CAMWEST

9th March 2024

Pippita Rail Trail Masterplan Feedback

Figure 1 - Marked-up topographical map of the Lidcombe end of Pippita Rail Trail.^[5]

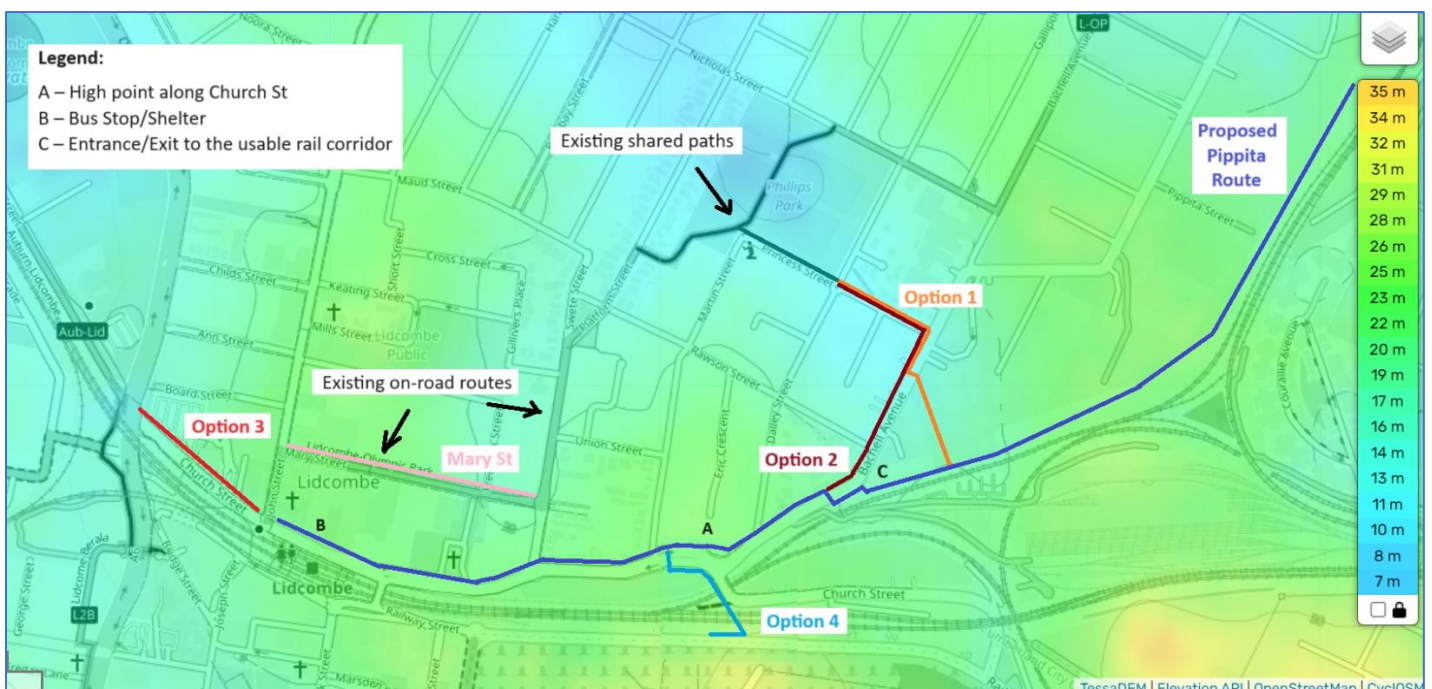
Route Options/Suggestions from the above map (Figure 1):

1. One of the traditional advantages of a “Rail Trail” is the use of the rail corridor which provides a very gradual change in gradient. Between Lidcombe station and Point C on Figure 1 (near the corner of Bachell Ave and Rawson St) it’s not possible to use the rail corridor. The scope of the project between these points appears to have been limited to Church St and Bachell Ave corridors. While the route is quite direct, we feel it’s more undulating than a more circuitous option consisting of John St, Mary St (which as mentioned above is proposed to have a separated 3m wide bi-directional cycleway and goes past St Joachim’s Catholic Primary School), Swete St, Platform St, the existing shared paths alongside Phillips Park and through what we presume is a creek easement (although the section near Bachell Ave is currently being used for storage). See the Orange route marked ‘Option 1’ on Figure 1.

2. If Option 1 is ruled out, we’d like to see Option 2 considered – at least initially between the proposed crossing of Bachell Ave and Rawson St. This would provide some reasonably direct connectivity to the rail-trail corridor from the broader residential areas of Lidcombe.

3. Starting the route at Lidcombe station may be suitable for those catching the train, but it may preclude some of those who would like to ride to/from the Lidcombe end of the route. While confident riders may readily handle the 240m slight to moderate road incline along Church St from Olympic Drive to John St, we feel that a fair proportion of the riders that would be attracted to the Pippita Trail would feel uncomfortable riding this section. The cycling network on the western side of Olympic Drive is not great, but there is at least some connectivity there – particularly along the railway line to Auburn. We believe this link along Church St should be built to coincide with the opening of the rail trail which would increase its attractiveness to a larger pool of riders.

Figure 2 - Map from Page 9 of *The Plan*.

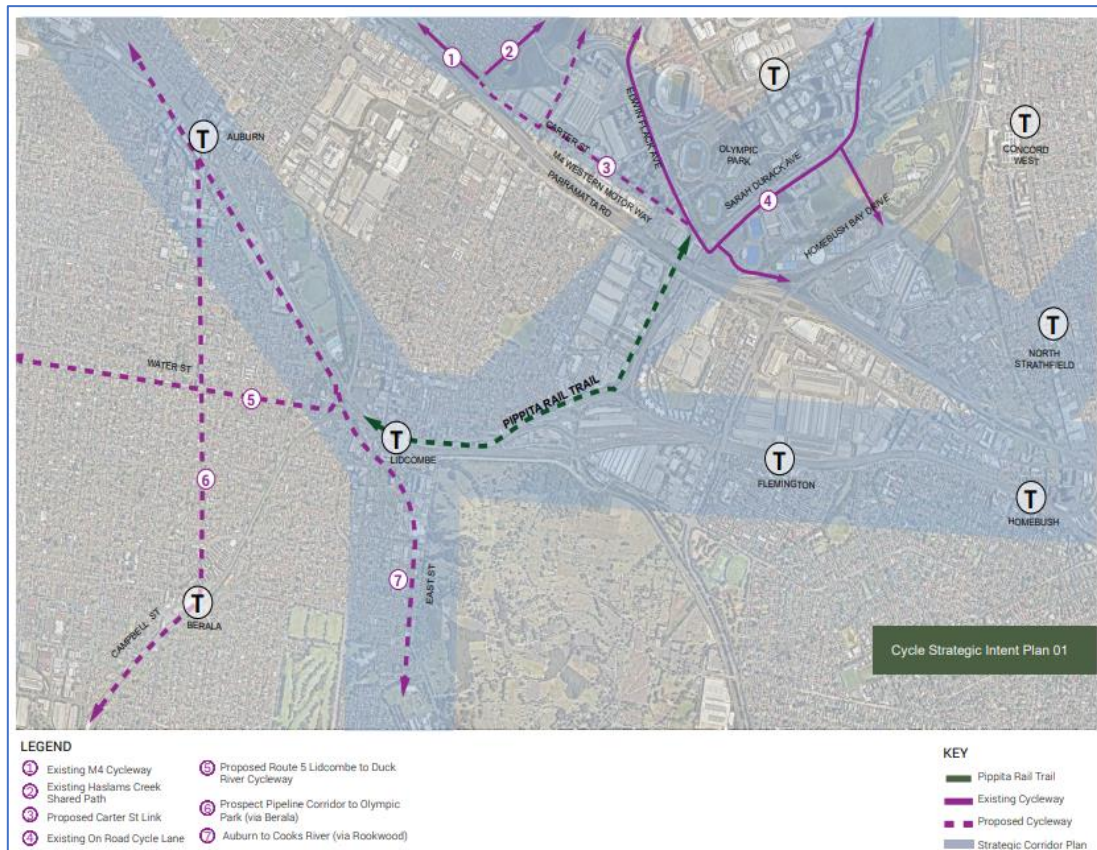
We are still struggling to see how the Pippita Rail Trail really fits in to encouraging the uptake of Active Transport (AT) in the wider area. The below map in *The Plan* which reflect the AT corridors in the Draft Cumberland Walking and Cycling Strategy are very broad brush. As has been pointed out in our feedback of Town Centre Public Domain Plans for Guildford^[6] and Merrylands,^[7] there really needs to be 'mid-level' planning of AT routes around precincts in the Cumberland Local Government Area.

From the Draft Lidcombe Town Centre Public Domain Plan. ^[8]

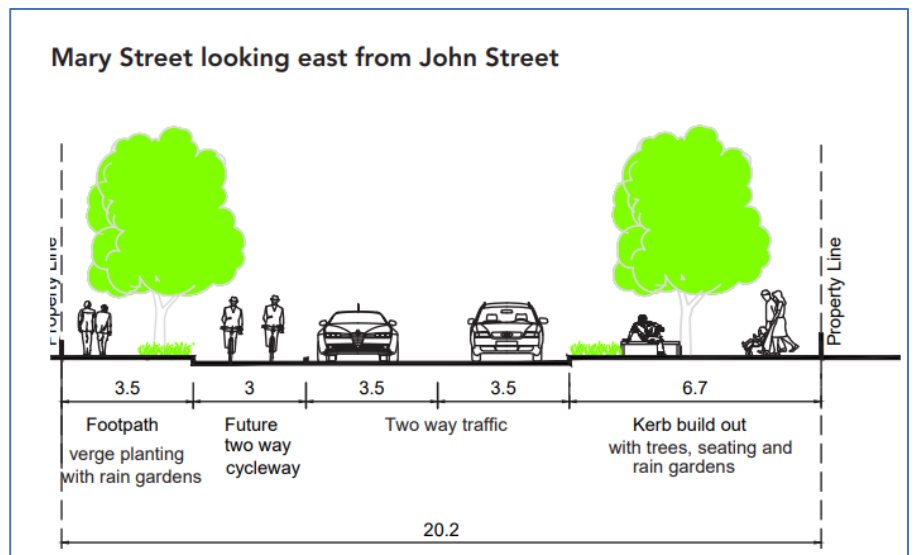
This image from the Draft Lidcombe Town Centre Public Domain Plan^[8] shows a proposal to construct a 3m wide cycleway along Mary St, but there are no indications that we can locate of how this will interface with John St and Swete St at either end. We see very little evidence of this 'mid-level' planning for Lidcombe either. We make several suggestions below.

Marked-up Google satellite view image showing part of ‘Option 1’ through what we presume is a creek easement between Bachell Ave and the Pippita corridor.

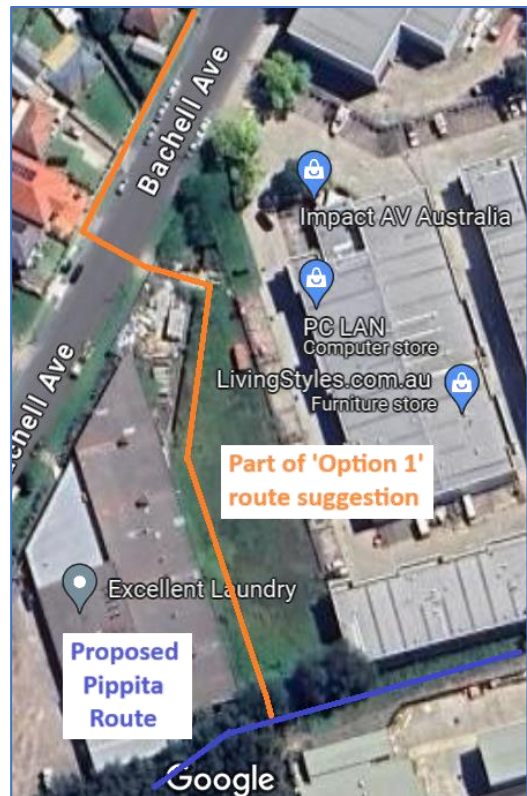
Some advantages of this route over the current proposed route are that it’s flatter (and more rail-trail like), it bypasses the problematic bus stop on Church St, and since it passes through more of the Lidcombe residential area rather than skirting around the edges, it would potentially have a wider local ‘catchment’.

Marked up Cycling-layer-enabled Open Street Map^[9] view of possible new path alongside Parramatta Rd.

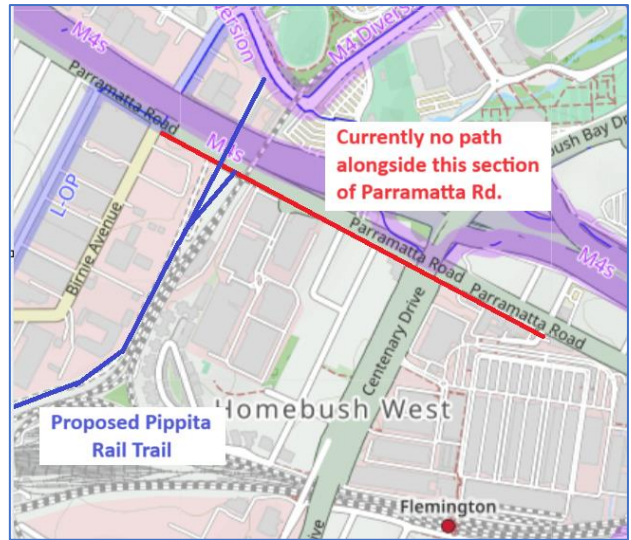
- One of the links in *The Plan* is for the Pippita Rail Trail to link with a shared path along the south side of Parramatta Rd – which doesn't currently exist. We're assuming the plan is to build the path between Birnie Ave intersection and the housing developments in Homebush West and possibly on to Flemington Markets. This is mentioned again below.
- We are disappointed that the bridge over Edwin Flack Ave is only proposed, and that once AT users descend from the embankment to Edwin Flack Ave, riders heading northwest towards the Birnie Ave/Shane Gould Ave intersection are expected to use the on-road cycle lane, while riders heading southeast from the intersection are able to use the 1.8m wide path along with pedestrians.

Diagram from CAMWEST's initial Pippita Rail Trail feedback.^[10] The preferred route (with the bridge) is around part of the Warm-Up Arena and along the marked blue and brown paths.

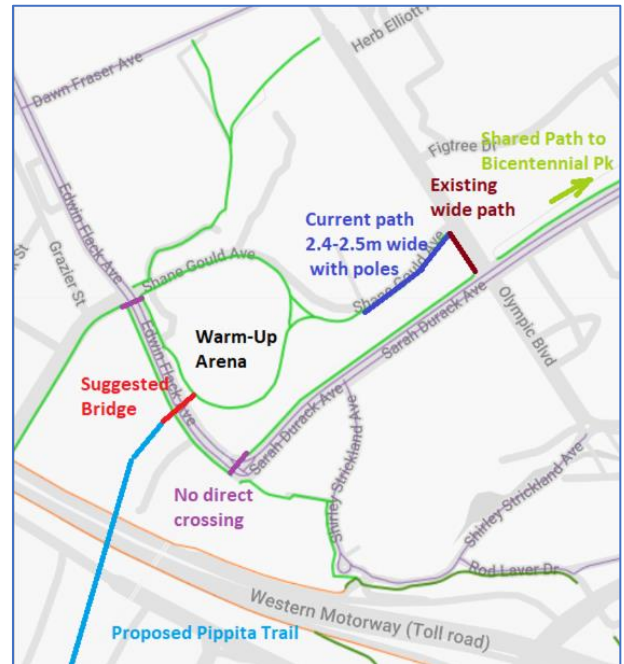
If the bridge doesn't proceed, we would like consideration given to installing a crossing of Edwin Flack Ave under where the proposed bridge would go in order to access the wider path on the opposite side. As shown by one of the purple lines in the diagram to the right, there is no direct crossing at the signalised intersection of Edwin Flack Ave and Shane Gould Ave, with AT users needing to cross Birnie Ave first.

We believe that some of the paths marked as green on this diagram are not currently recognised by Sydney Olympic Park Authority (SOPA) as shared paths. This is an area that requires clarification.

'Artist Impression' image of the separated Church St cycleway from page 44 of The Plan.

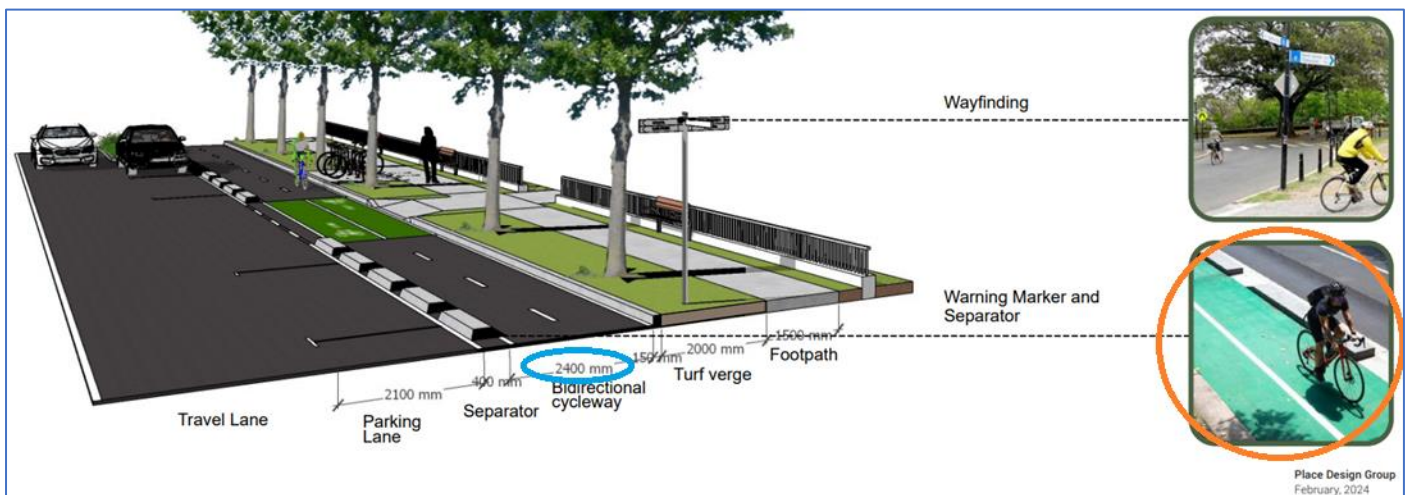
- We are disappointed to see that although a lot of the path is specified as 3 and 4m in width, according to the diagram below the separated cycleway has a width of 2.4m, which is less than the desirable minimum of 2.5m.^[11]

If the artist impression to the right and the orange circled image below are any guide, this width appears to include the road gutter as well. As a gutter is a place where road debris tends to gravitate and should be the wettest place during and immediately after rain events, we believe it should be excluded from any path width calculations. Surface height differences between the concrete gutter and road surface need to be carefully managed to minimise the risk of cycleway users catching their tyres and falling.

Drawing 02B, page 54 of The Plan

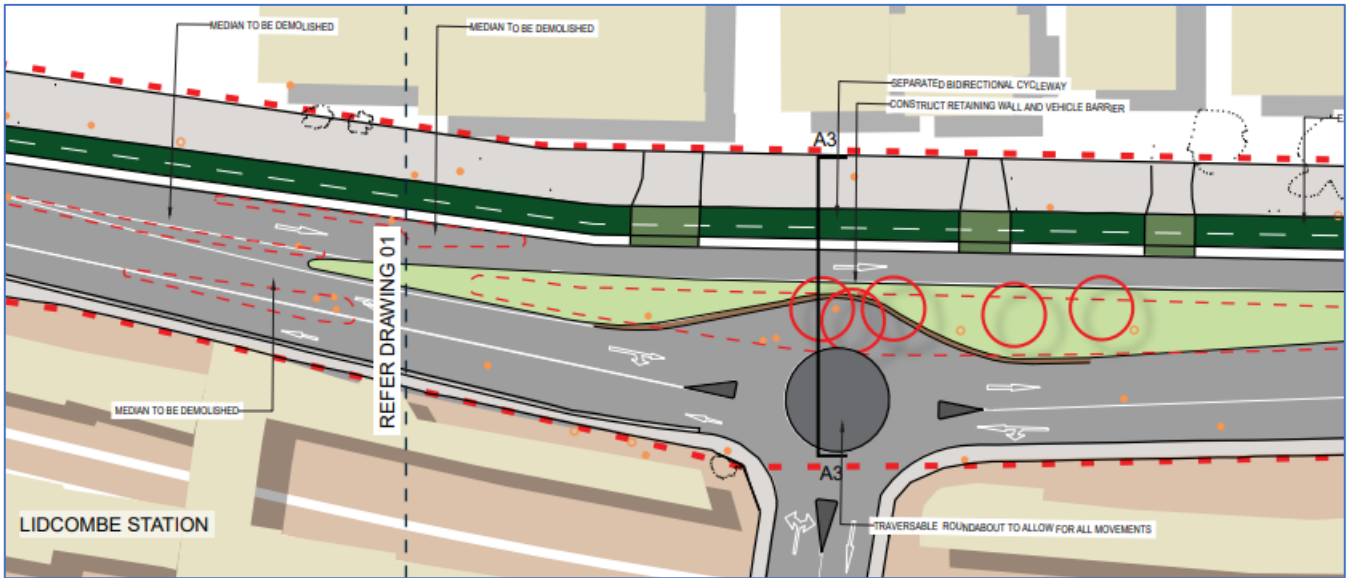
We quite like the option of a roundabout at the Church St overbridge (Drawing 02B) intersection instead of the largely current option (Drawing 02). We understand there may be some issues with this option though.

From our perspective, for Active Transport users this option would:

- Be advantageous as it converts some of the proposed shared path along Church St to separated path, although it is unclear as to the width of this path and exactly how and where it would integrate back to the shared path on the western end.
- For those riders comfortable to ride on-road with moderate traffic levels, it would slightly increase the ease of using the overbridge crossing to Railway St. Note however that only some riders may be comfortable with this option; it would not suit a lot of current and potential riders.

Figure 3 – Marked-up Cycling Layer enabled Open Street Map view of the area.^[12]

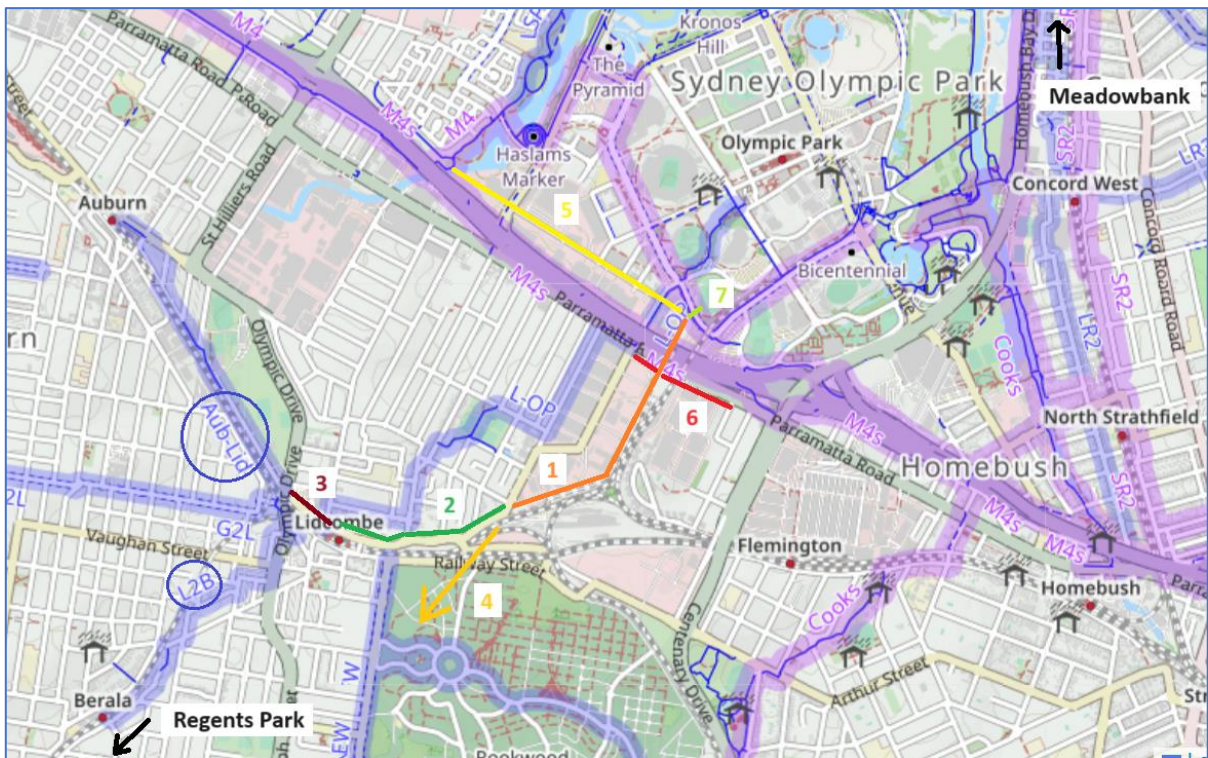
We don't view the Pippita Rail Trail project in isolation. The following points refer to the numbered corridors in Figure 3:

1. (Orange) - We prefer to view the section of the Pippita Rail Trail within the rail corridor and through to Edwin Flack Ave as part of the active transport north-south 'trunk'.

2. (Dark Green) - The section of the Pippita Rail Trail alongside Bachell Ave and Church St between the rail corridor and Lidcombe station can be viewed as one of the 'branches.'

3. (Brown) – An extension to [2] along Church St between John St and Olympic Drive (as previously mentioned).
4. (Light Orange) - The 'unknown' link across the railway line which could potentially form part of the north-south trunk. The current railway underpass at the eastern end of Church St is already a tight fit widthwise for heavy vehicles, so without major works we can't see how a shared path could be squeezed in there as well. We believe a new bridge further back towards Lidcombe is the best option for crossing the railway line.

5. (Yellow) – Across Haslams Ck and along Carter Street linking the current M4 path to the Pippita Rail Trail. This could be considered part of the 'East-West' trunk.

6. (Red) - Shown alongside Parramatta Rd between Birnie Ave and Telopea Ave in Homebush West (and possibly extending to Flemington Markets), this is another branch off the Pippita north-south trunk.

7. (Light green) – Bridge over Edwin Flack Ave would form an integral link in the north-south trunk heading to Bicentennial Park, Rhodes, Meadowbank and beyond.

We think Figure 3 routes 3 and 6 together with the Rail Trail approximate the vision laid out in the CRC strategy document.

Even without the corridor 4 bridge over the railway line, a reasonable on and off-road route heading southwest to Berala and Regents Park could be possible if Corridor 3 was completed and some of the footpaths alongside Olympic Drive widened to shared path width as in the Figure 3 unofficial 'L2B' Lidcombe to Berala route.

Part of the Central River City Strategic Cycleway Corridor document.^[13]

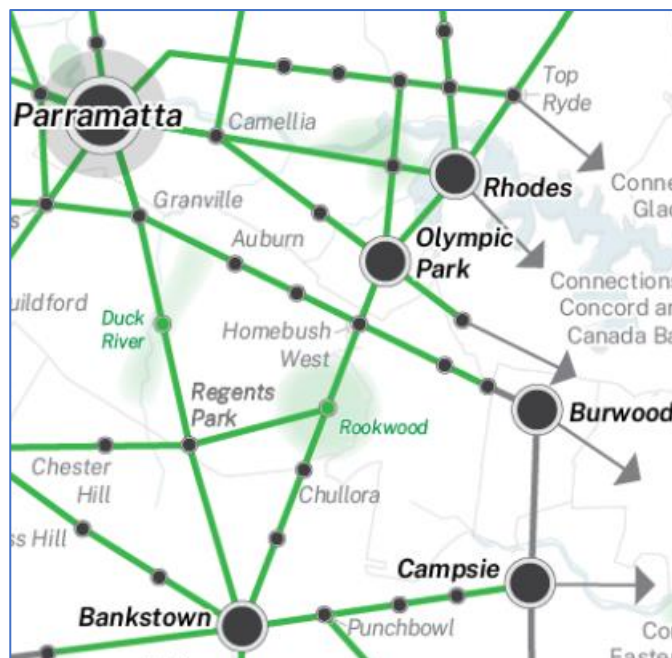
We note that the Auburn to Regents Park corridor in Figure 2 (Cumberland Council Route 6) is not identified as aligning with the CRC strategic corridors. Together with the 'Aub-Lid' route in Figure 3, the L2B route may be a viable contender for a large part of this Auburn to Regents Park route, with the bonus of virtually including Lidcombe in the route.
